**PACKET OF PUBLIC COMMENT**

Advisory Plan Commission

July 6, 2015

### **Subject: ORD 15-14, Tamarack**

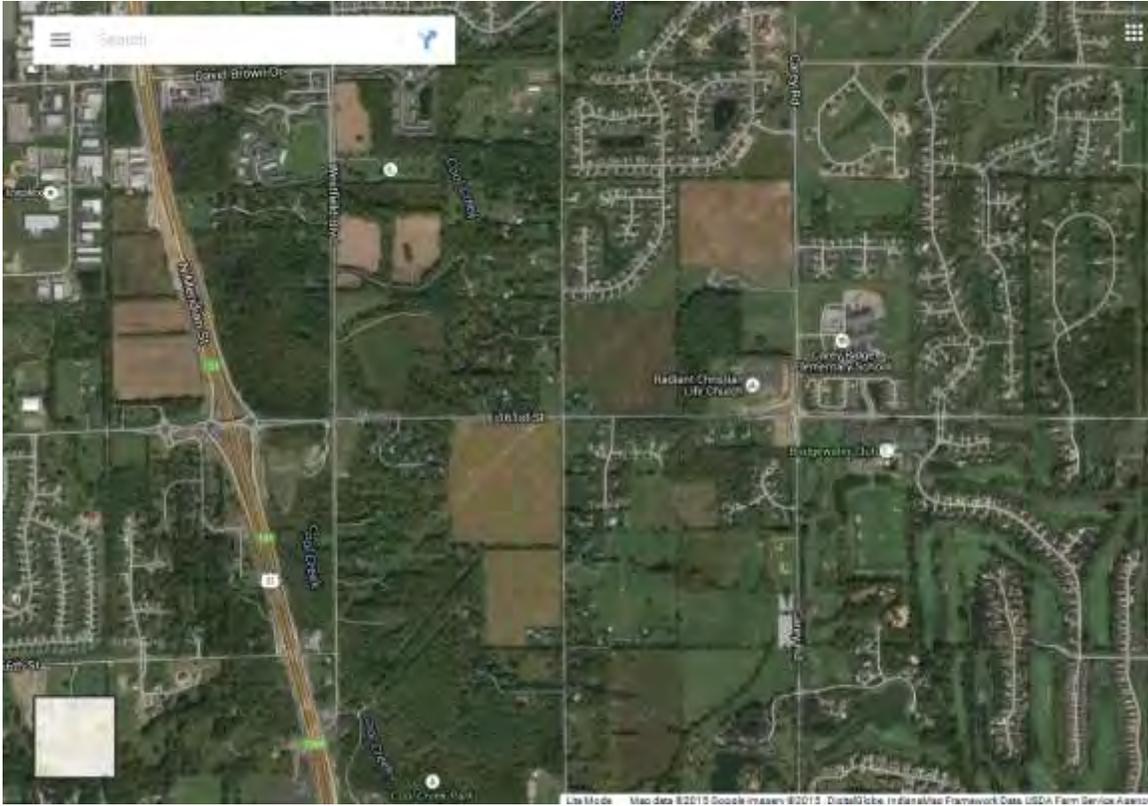
decreasing the heat intensity at the site of the second object to 1/16<sup>th</sup> of what it would be adjacent to the first object results in a further exponential decrease in heat transfer to (and combustion of) the second object. The same pipeline explosion would have been markedly less devastating if the area where it occurred were less densely built. The initial blast would have damaged and destroyed fewer homes and the rate and probability of fire spreading to adjacent structures would have decreased exponentially.

Applying the above principles, keeping the minimum 12-foot side yard setbacks required of the current SF-2 zoning compared to the 5-foot setbacks will result in minimum 24-foot separation between structures vs 10 as requested. This reduces the heat intensity at the second structure to ~17% of what it would be with 10-foot spacing with heat transfer proportional to <1% of what it would otherwise be. If the council and developer could be visionary enough to commit to minimum 20-foot setbacks (40 feet between structures), these numbers could be reduced to 6.25% and <0.01%, tremendously reducing the risk of fire spread between structures whether due to a pipeline disaster or much more “usual and customary” causes of house fires.

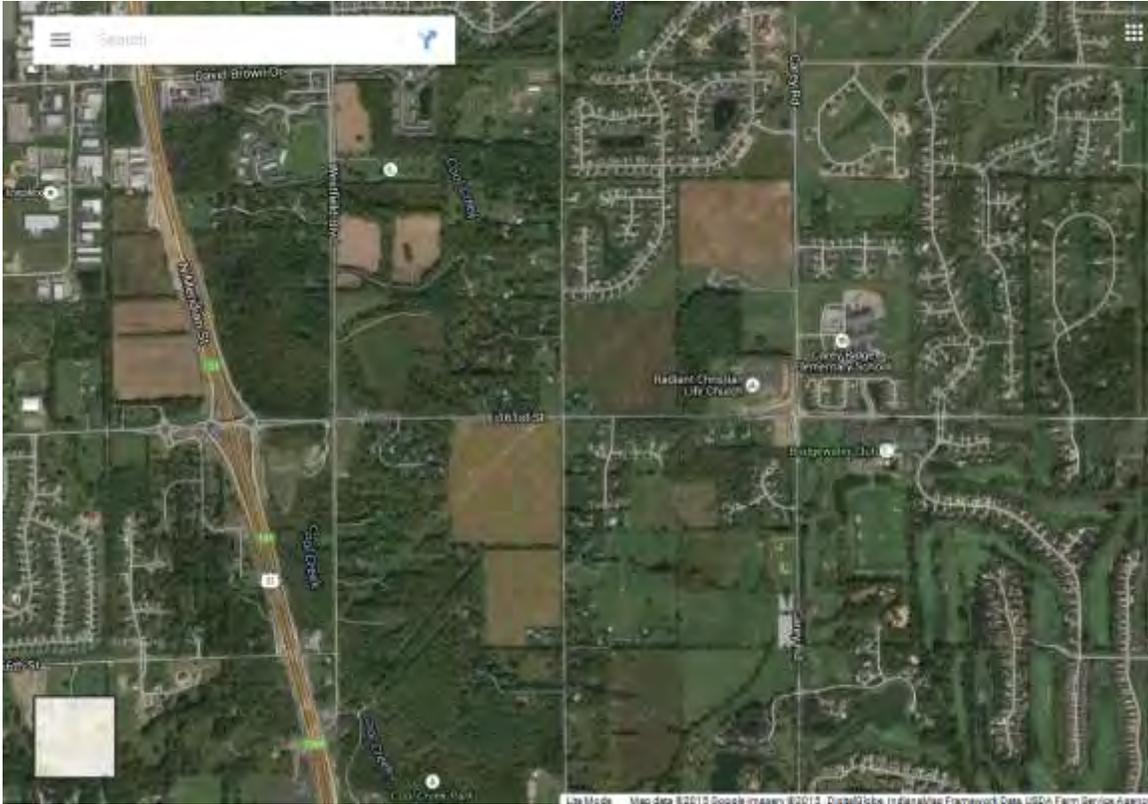
decreasing the heat intensity at the site of the second object to  $1/16^{\text{th}}$  of what it would be adjacent to the first object results in a further exponential decrease in heat transfer to (and combustion of) the second object. The same pipeline explosion would have been markedly less devastating if the area where it occurred were less densely built. The initial blast would have damaged and destroyed fewer homes and the rate and probability of fire spreading to adjacent structures would have decreased exponentially.

Applying the above principles, keeping the minimum 12-foot side yard setbacks required of the current SF-2 zoning compared to the 5-foot setbacks will result in minimum 24-foot separation between structures vs 10 as requested. This reduces the heat intensity at the second structure to ~17% of what it would be with 10-foot spacing with heat transfer proportional to <1% of what it would otherwise be. If the council and developer could be visionary enough to commit to minimum 20-foot setbacks (40 feet between structures), these numbers could be reduced to 6.25% and <0.01%, tremendously reducing the risk of fire spread between structures whether due to a pipeline disaster or much more “usual and customary” causes of house fires.
